**Section 12A Planning Application No. Y/NE-LYT/16**

Request for Amendment to the Approved Lung Yeuk Tau and Kwan Tei South Outline Zoning Plan No.S/NE-LYT/19 from “Residential (Group C)” Zone and “Agriculture” Zone to “Residential (Group A)2” Zone at Various Lots in D.D. 83 and Adjoining Government Land in D.D. 83, Lung Yeuk Tau, New Territories

*Further Information (10)  
Responses-to-Comments Table  
3 January 2025*

**Responses-to-Comments Table**

Drawing Title  
**MASTER LAYOUT PLAN ROOF**

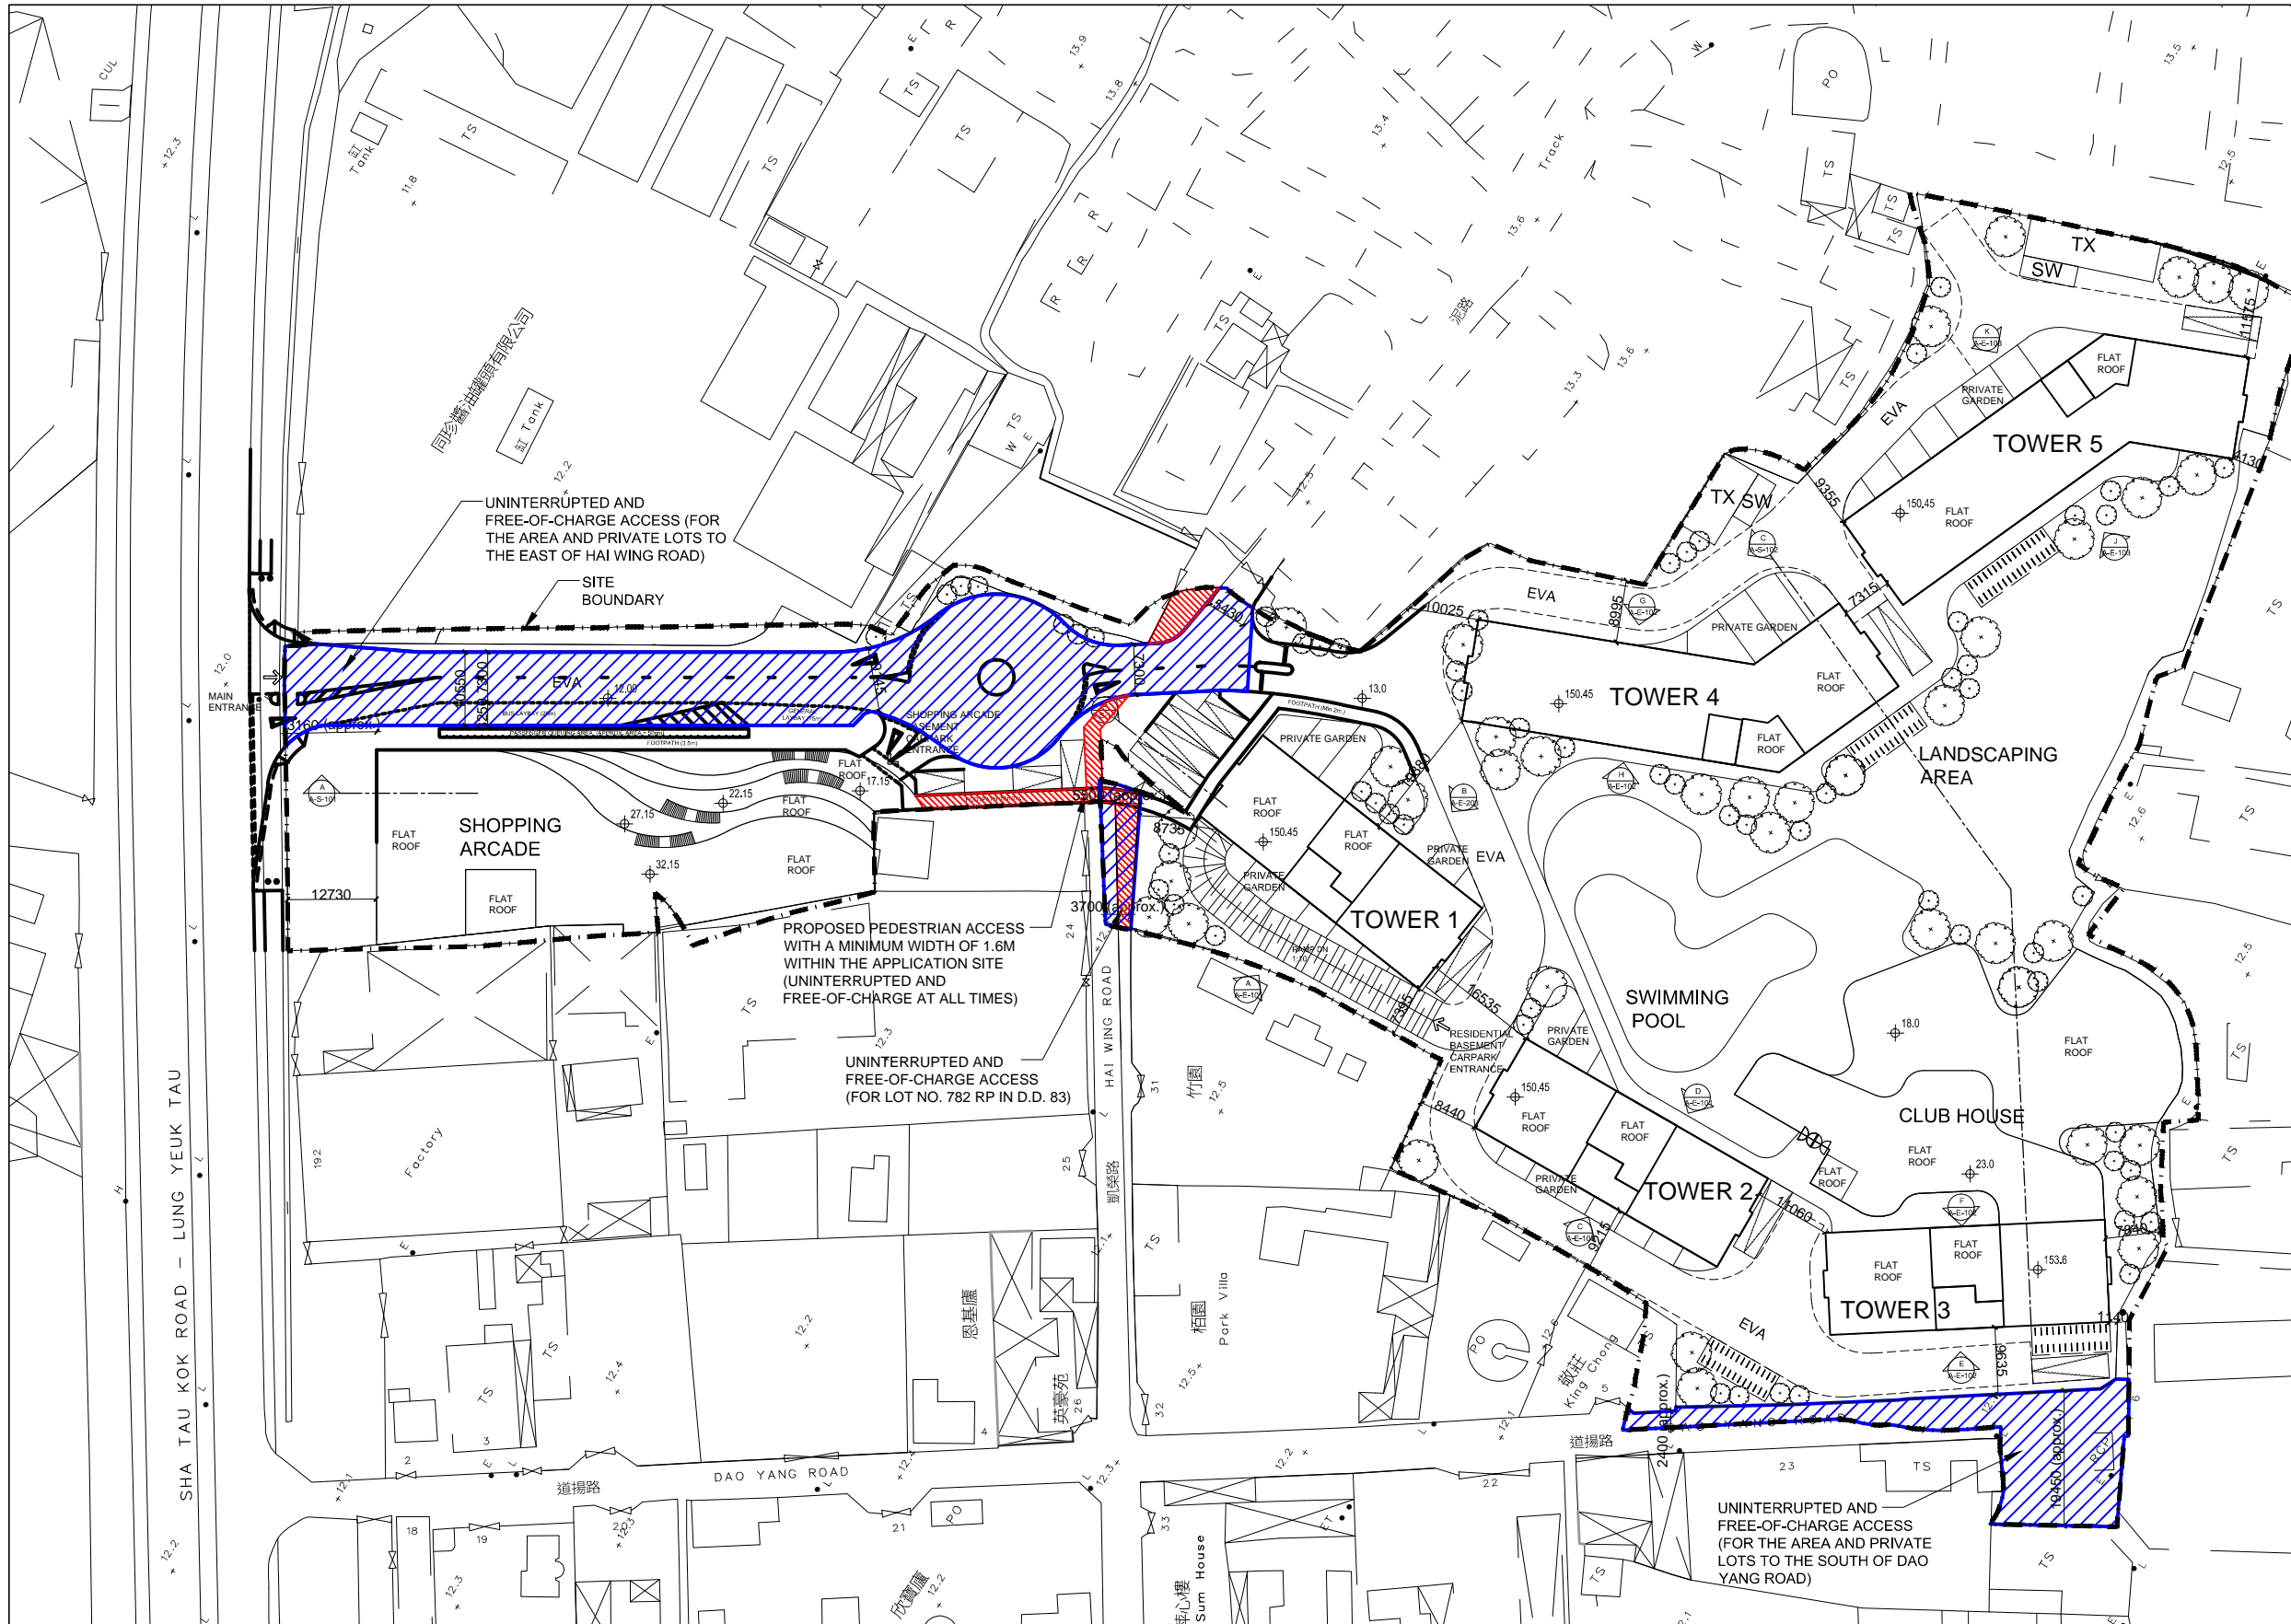
4. Subject to the above said, our further comments are provided: - (i) The applicant advised in the Table of Response-to-Comments that a pedestrian footpath with a <u>maximum</u> width of 1.6m for access to and from Lot No 782 RP in D.D. 83 would be provided within the application site, while a <u>minimum</u> width of 1.6m was indicated in the plan of Illustration 4. The applicant should clarify whether a pedestrian footpath with a maximum or minimum width of 1.6m for access to and from Lot No. 782 RP in D.D. 83 would be provided within the application site.	It is clarified that the proposed pedestrian footpath with a <b>minimum</b> width of 1.6m for access to and from Lot No. 782 RP would be uninterrupted and free of charge at all times, and detailed alignment and implementation conditions will be subject to further liaison with Lands Department during the land exchange stage.
		(ii) R-to-C mentioned “Currently, there is no established vehicular access from Hai Wing Road to adjoining lots. In order to cater for the proposed development of the subject site, and to minimize unnecessary impacts to the existing land uses in the neighbourhood. In view of the above, it is considered that status quo is appropriate in this case.” This office is doubtful on implication of such statement as motor vehicles are using access road from Hai Wing Road to	Access from Hai Wing Road to adjoining lots would be maintained, please refer to the attached MLP.

Date	Department	Comments	Responses
		adjoining lots and such statement will pre-empt Government’s position in case of queries from adjoining lot owners.	
		(iii) Without indication on alignment and width of the proposed uninterrupted and free-of-charge access for (i), (ii) the area and private lots to the south of Dao Yang Road (such as Lots Nos. 856 and 2144 both in D.D. 83) and (iii) the area and private lots to the east of Hai Wing Road (such as Lot Nos. 778 ad 780 both in D.D. 83) on the master layout plan and the plan of Illustration 4, the commitments for allowing access is subject to dispute by the concerned parties.	Please refer to the attached MLP.
